DEVELOPMENT APPLICATION ASSESSMENT REPORT

Application Number:	DA2023/1675
----------------------------	-------------

Responsible Officer:	Mark Milton
Land to be developed (Address):	Lot 1 DP 28559, 48 Warriewood Road WARRIEWOOD NSW 2102
Proposed Development:	Alterations and additions to a dwelling house
Zoning:	R2 Low Density Residential
Development Permissible:	Yes
Existing Use Rights:	No
Consent Authority:	Northern Beaches Council
Land and Environment Court Action:	No
Owner:	Hubert Stefan Wiest Janina Von Stebut
Applicant:	Karen Victoria Buckingham

Image 1. Southern elevation building envelope non-compliance.

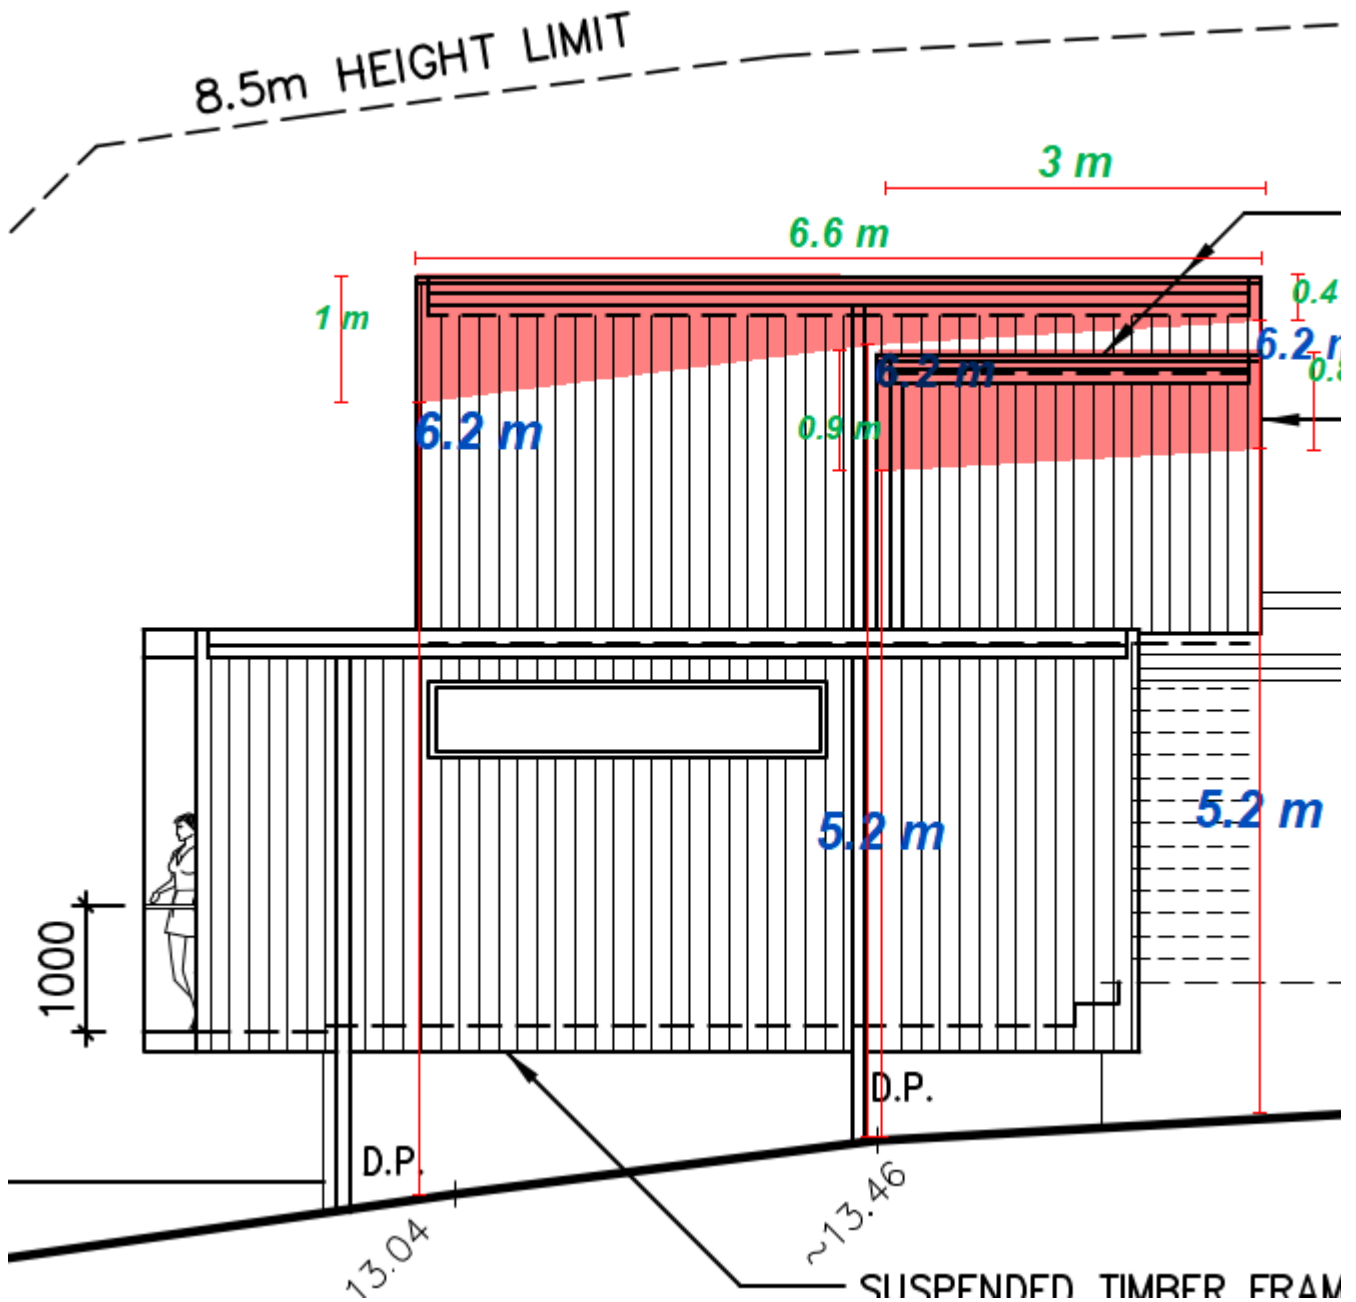
The proposal extends beyond the building envelope control on the southern elevation. There is one 6.6m-long non-compliance of 0.4m-1m in height (guest bedroom), and a second 3m-long non-compliance of 0.8m-0.9m in height (office). This non-compliance is visualized on Image 1 below.

Notwithstanding the breach of the building envelope, the proposed development is consisted to appropriately respond to the spatial characteristics of the site and surrounds and appropriately mitigates built form impact on adjacent properties. The development demonstrates a compliant building height and does not require the removal of any existing vegetation.

Notwithstanding the non-compliance, it is considered that the bulk and scale of the built form has been minimised through the articulated design, compliant height and setbacks.

As the existing dwelling is retained with this application, a variation may be permissible, subject to the following assessment of the proposal's merits against the outcomes of the control.

Having regard to the above assessment, it is concluded that the proposed development is consistent with the relevant objectives of P21DCP and the objectives specified in s1.3 of the Environmental Planning and Assessment Act 1979. Accordingly, this assessment finds that the proposal is supported, in this particular circumstance.
